Re: GCC Energy, LLC, King II Mine
CDRMS Permit # C-1981-035
Minor Revision 54: Midterm Permit Review (MT-9) Response

Please find attached the pages addressing the items identified in Section VI of the Midterm Permit Review (MT-9), dated May 21, 2025.

**Appendix 8(9) King II
(MR-54)**

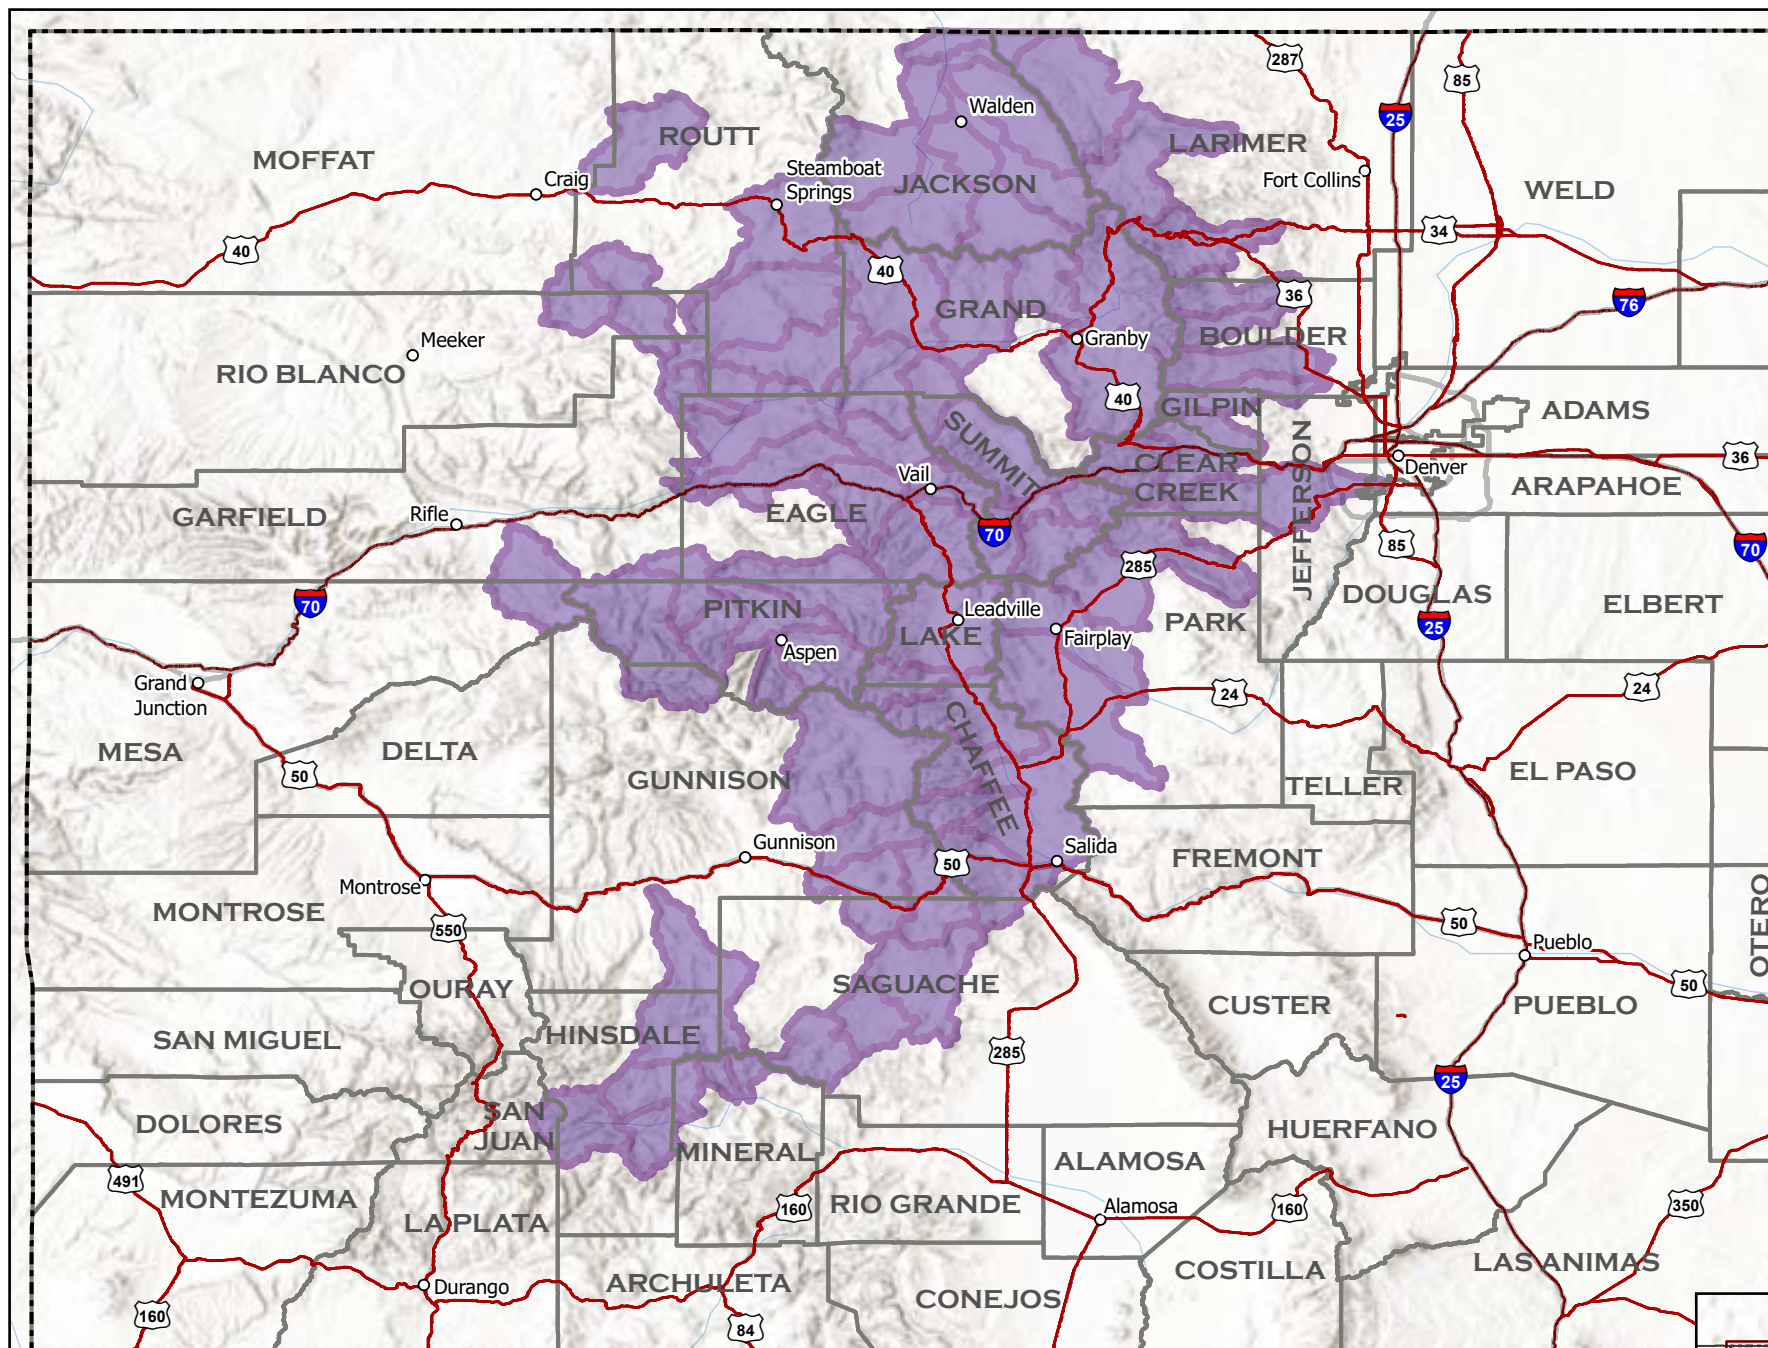
Also updated in this revision is Page 5 of Section 2.04.11. This has been amended to include Gray Wolves in the PAP's endangered species list. Appendix 8(9) has also been added to support this update.

Proposition 114, now codified as state law (33-2-105.8), was passed in November 2020 and directed Colorado Parks and Wildlife to reintroduce and manage gray wolves. Since their release in December 2023, several wolves have been tracked near the La Plata County line (see Appendix 8(9)). GCCE will continue to monitor their presence and will coordinate with the appropriate State and Federal agencies to assess any potential impacts.
